Addendum No. 1

CITY OF ABERDEEN ABERDEEN, MARYLAND DEPARTMENT OF PUBLIC WORKS

AWWTP Digester Gas Flare Replacement

Engineering Project No. 12563982

Title	EROSION AND SEDIMENTATION CONTROL SITE PLAN
Sheet No.	CE-00103
Sheet of	1

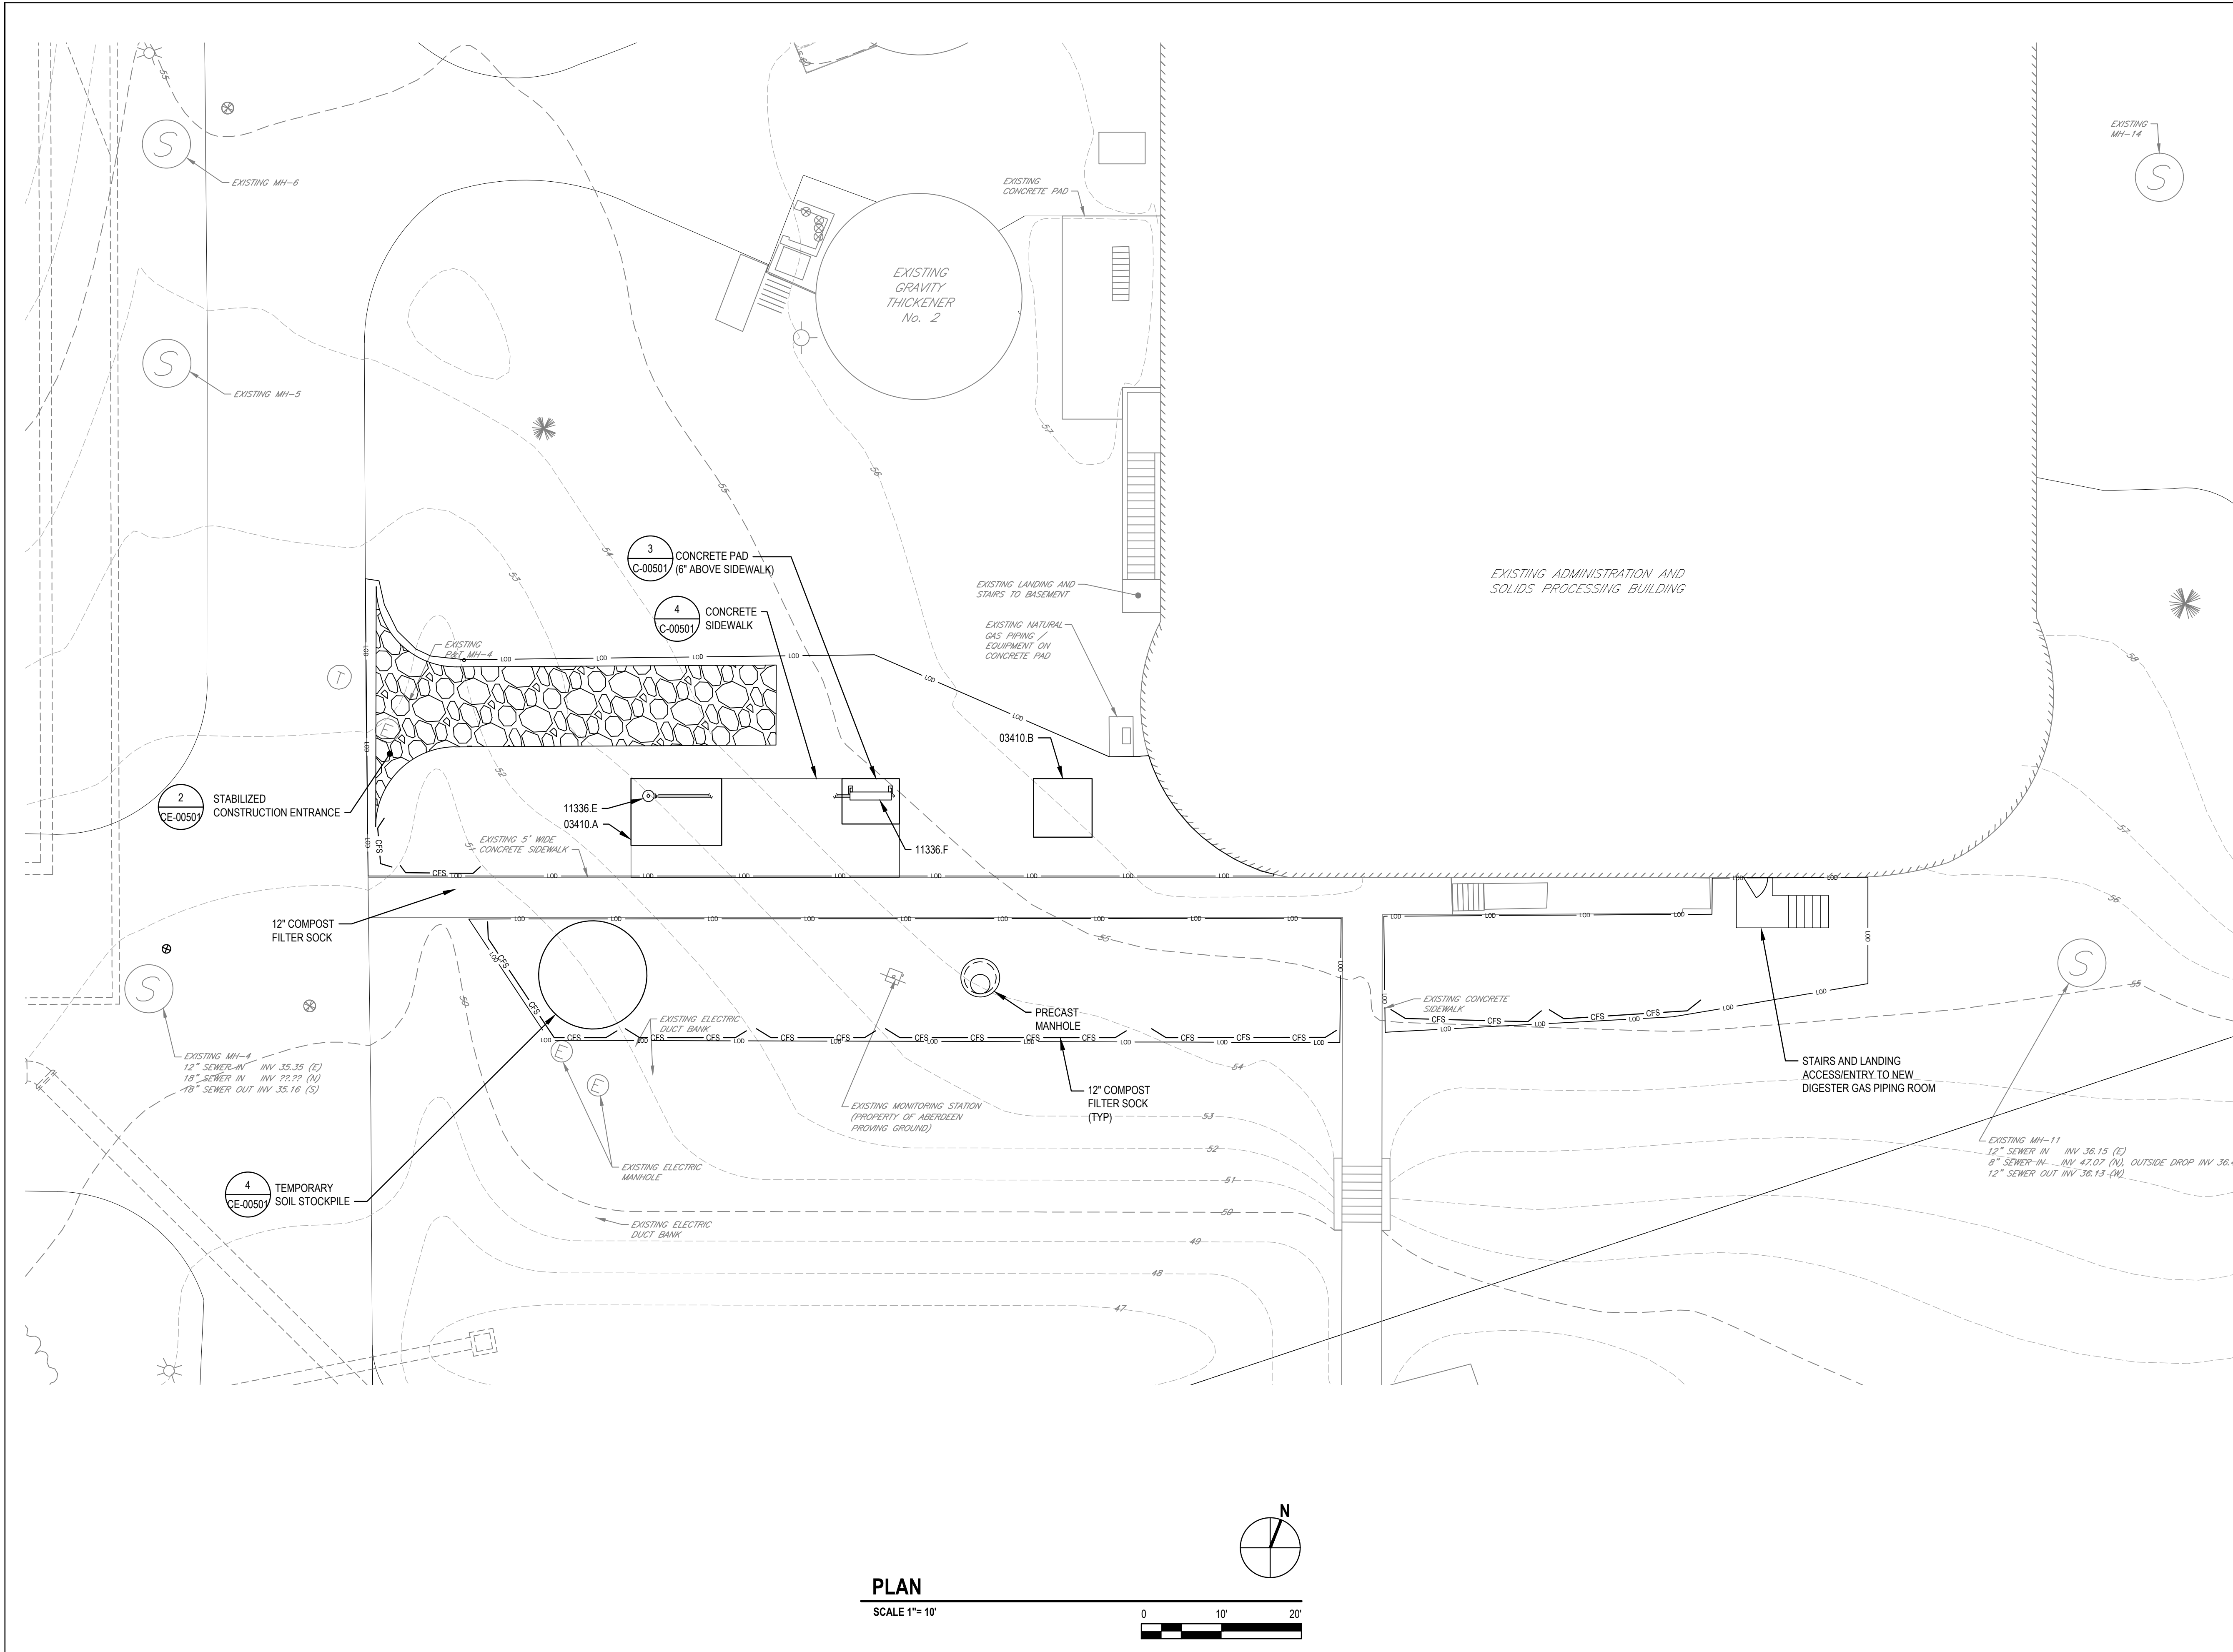
11. *We assume no construction entrance, concrete washout, silt fence and temporary seeds requirements are applicable to this project as not are included on the plans.*
 - a. Refer to the Erosion and Sedimentation Control plan and narrative drawings CE0001, CE00101 and CE00501 to be included as part of this contract.
12. *Are there any special security requirements for access to the project site for this project?*
 - a. There are no specific security clearances required for access to the project site. Contractor is responsible for checking in with the administrative office during each site visit.
13. *Are there any special safety requirements for work on this site?*
 - a. The project work involves demolition and construction around an operating wastewater treatment plant. Contractor shall follow all OSHA guidelines for work of this type.

Title	DRIP TRAP CHAMBER PLANS AND SECTION
Sheet No.	D-02101
Sheet	19 of 28

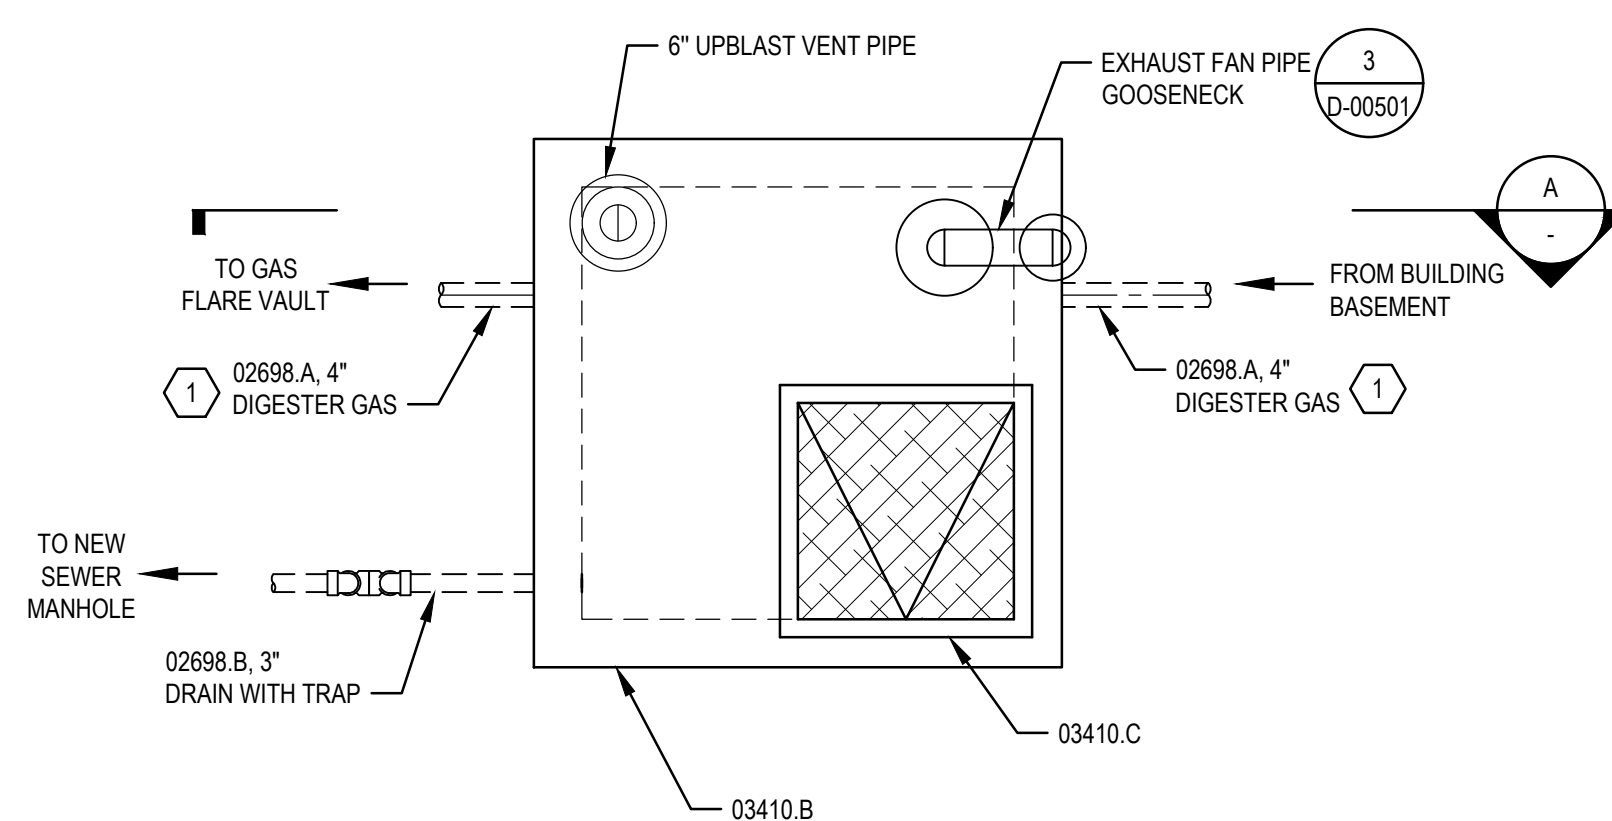
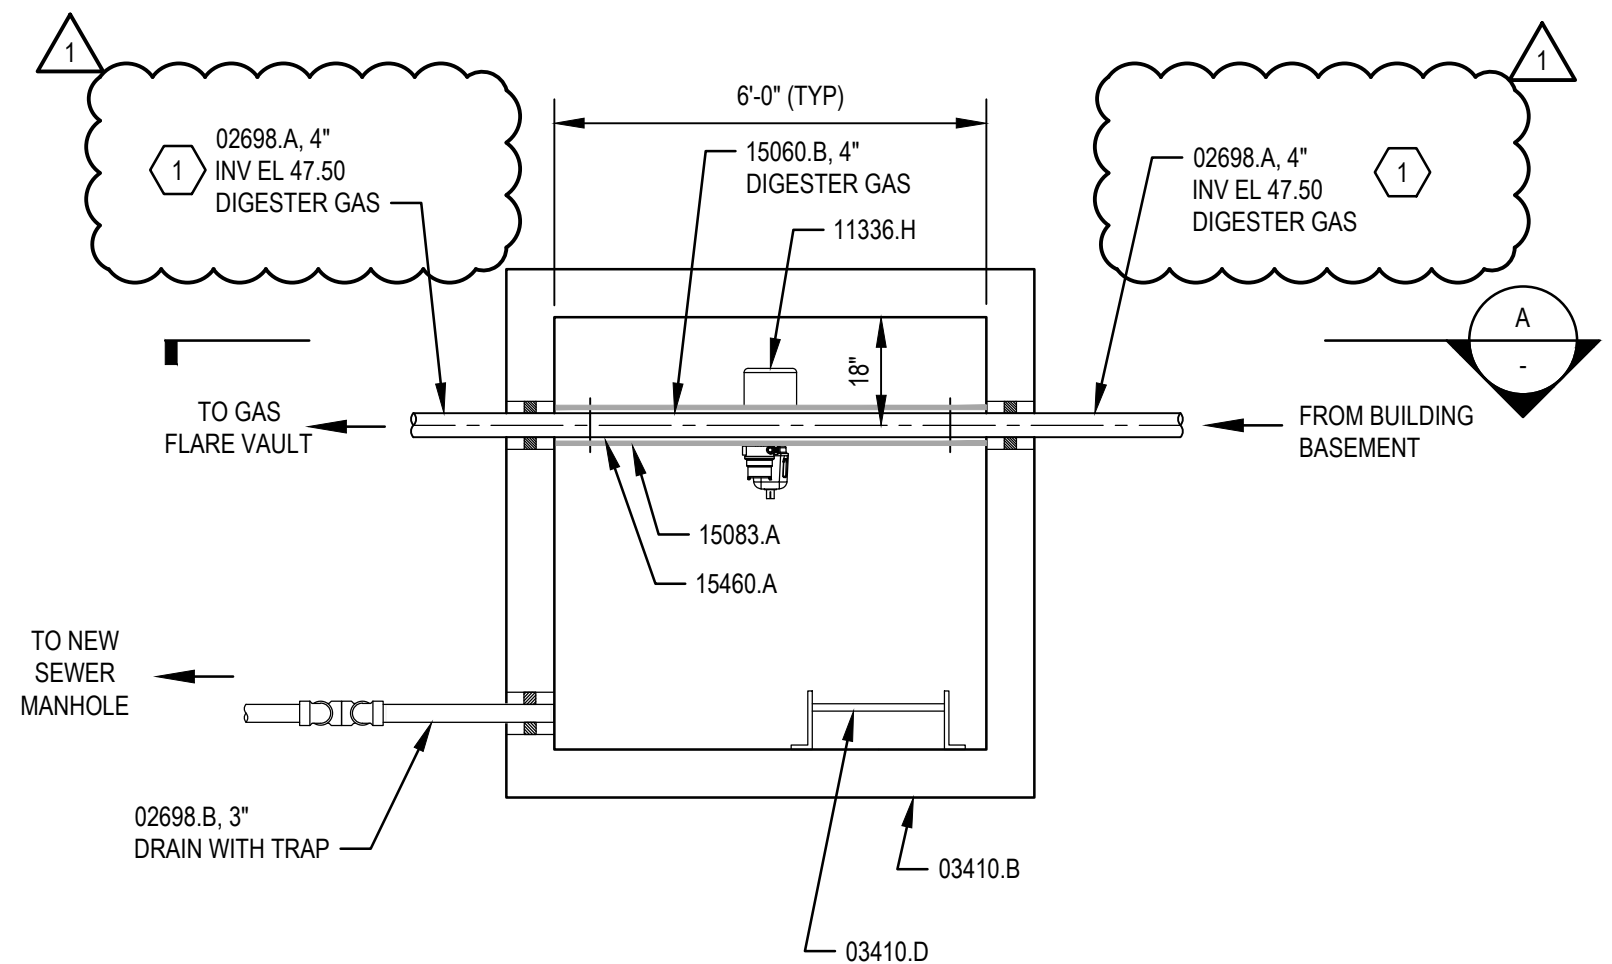
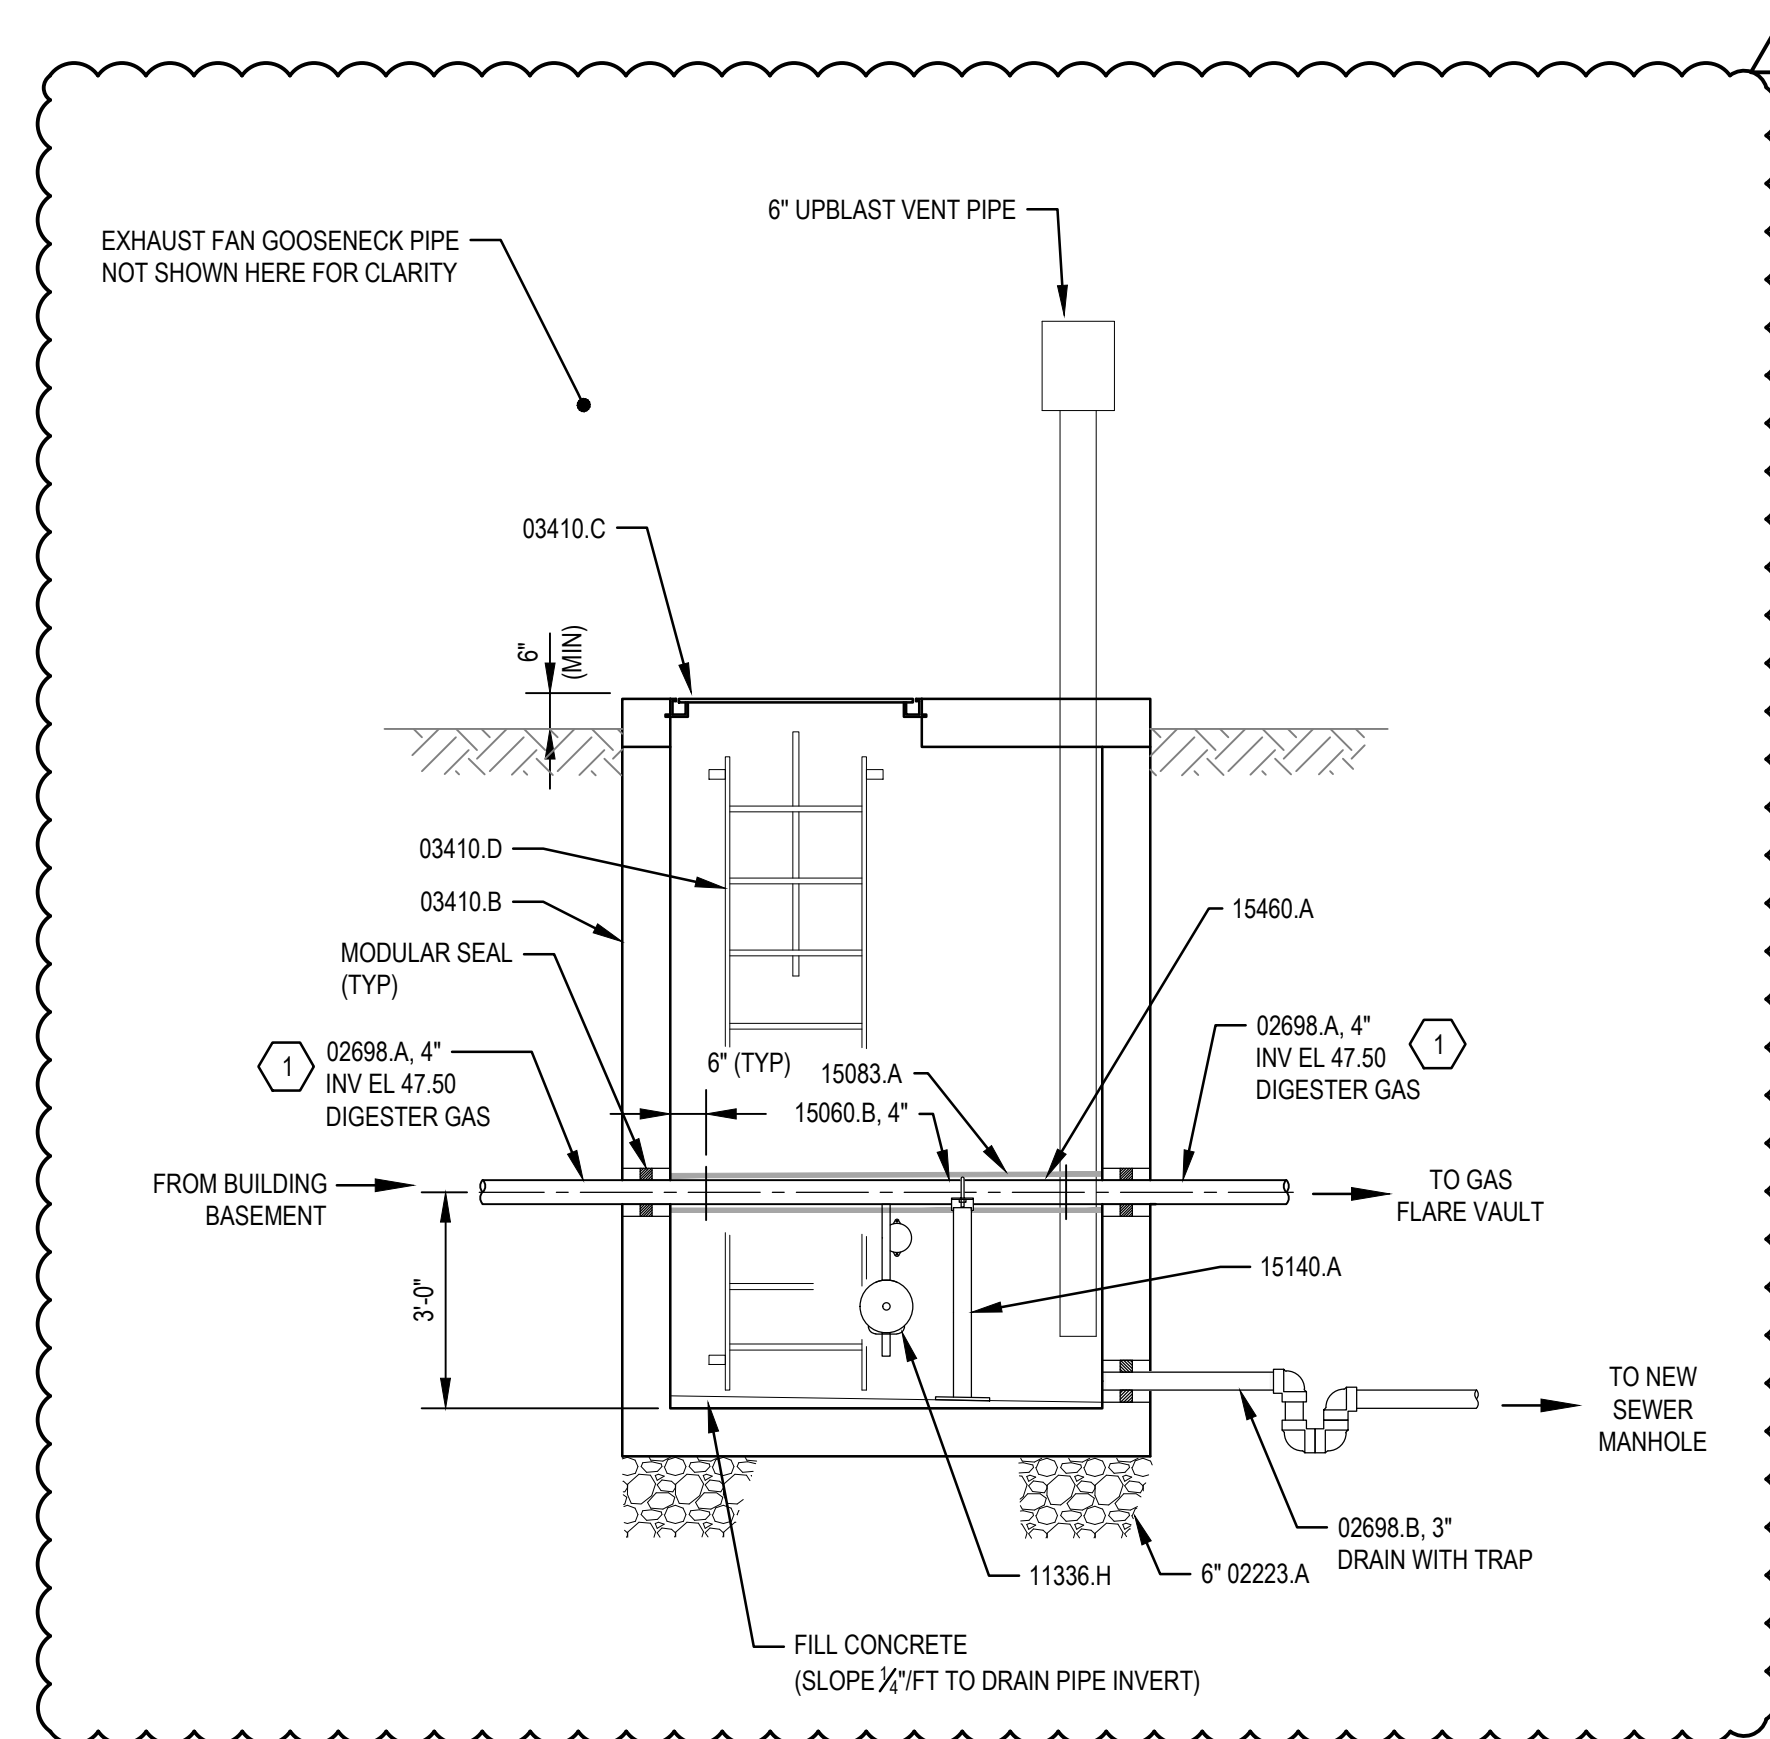
9. *Based on the scaled drawings, the Precast Flare Vault appears to be less than 8ft inside height, while the Precast Drip Trap Chamber appears to be approximately 15ft inside height. We assume we are not to scale these dimensions but should calculate the height based on the required slope and location of the 4” digester gas line at the penetration of the Digester Building. Please provide the following elevations for the 4” digester gas line: Invert at Building Basement Wall, Invert at Precast Drip Trap*

10. *Chamber and Invert at Precast Flare Vault.*

For questions 10 and 11 above, see the attached revised Sheet D02101.

- 1. CONTRACTOR TO INSTALL PIPE WITH 2% (MIN) SLOPE TO DRIP TRAP CHAMBER.
